IDAP REPORT

Property:	49 Shortland Avenue STRATHFIELD DA2020/190 Lot 11 DP 12405
Proposal:	Demolition of the existing structures and construction of a two-storey dwelling with basement level, in-ground swimming pool, cabana and associated landscaping.
Applicant:	E Sleiman
Owner:	C Francis & J G Ayoub
Date of lodgement:	16 November 2020
Notification period:	4 December – 18 December 2020
Submissions received:	No submissions made
Assessment officer:	J Gillies
Estimated cost of works:	\$962,937.00
Zoning:	R2-Low Density Residential - SLEP 2012
Heritage:	No
Flood affected:	No
Is a Clause 4.6 Variation Proposed:	No
RECOMMENDATION OF OFFICER:	APPROVAL

11.0 TREE IDENTIFICATION BASED ON PROPOSED DEVELOPMENT

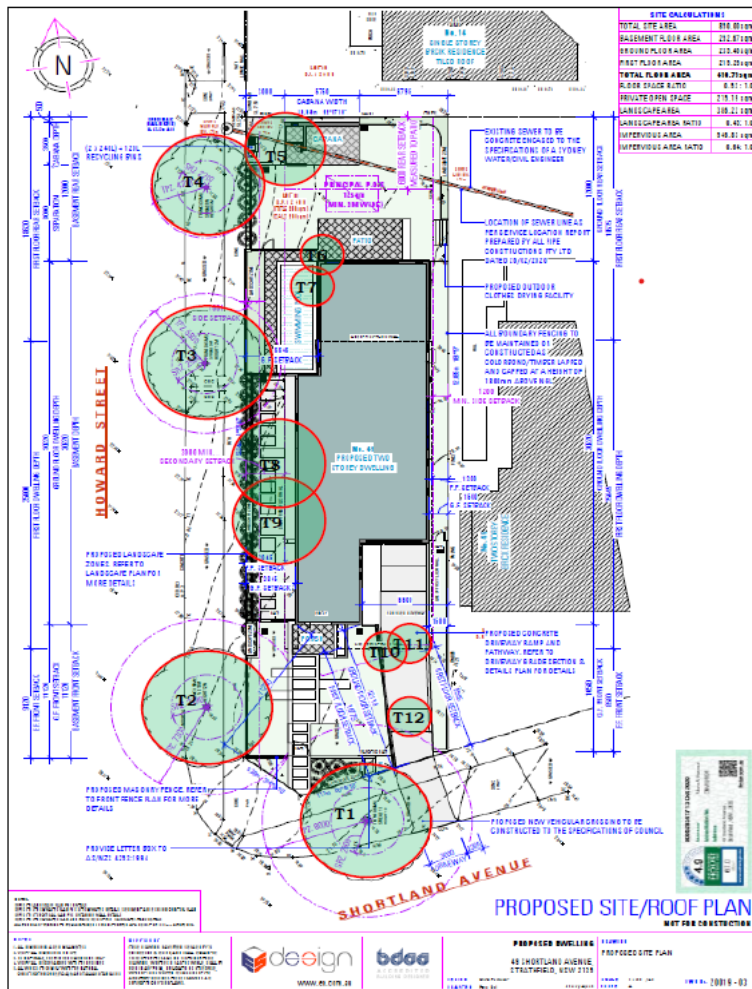
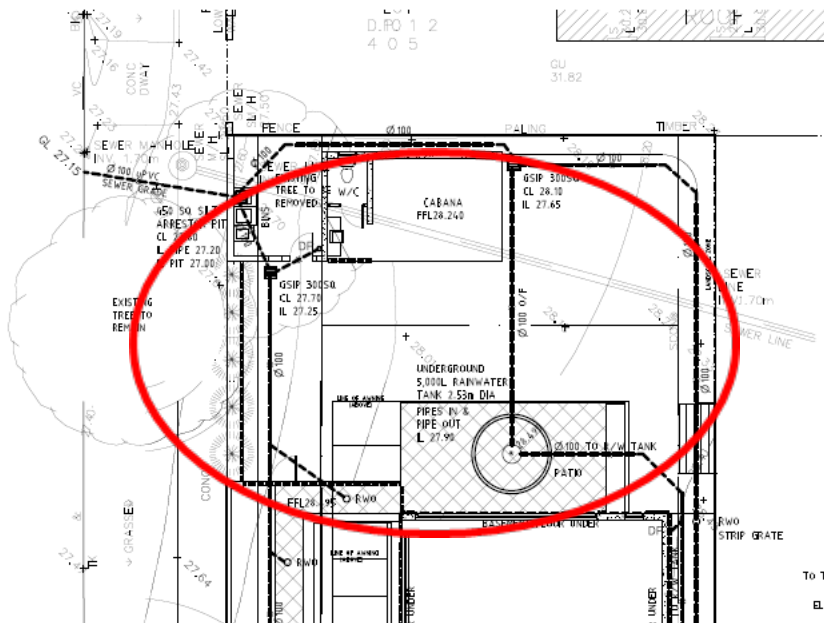
The trees numbered T5, T6, T7, T8 T9 T10, T11 and T12 are proposed to be removed.

I have no objection to the removal of the seven (7) trees numbered T6-T12

Tree T5 (Jacarada) is to be retained and protected.

This will require the design to be amended to relocate or delete the cabana and much of the proposed stormwater pipes. The landscape plan also needs to be amended to show the protection of T5. The arborist report will need to be amended to provide tree protection information for during demolition and construction.

The above advice was provided to the Applicant and a revised design incorporating relocation of the Cabana and retention of the Jacaranda Tree was submitted via the NSW Planning Portal.
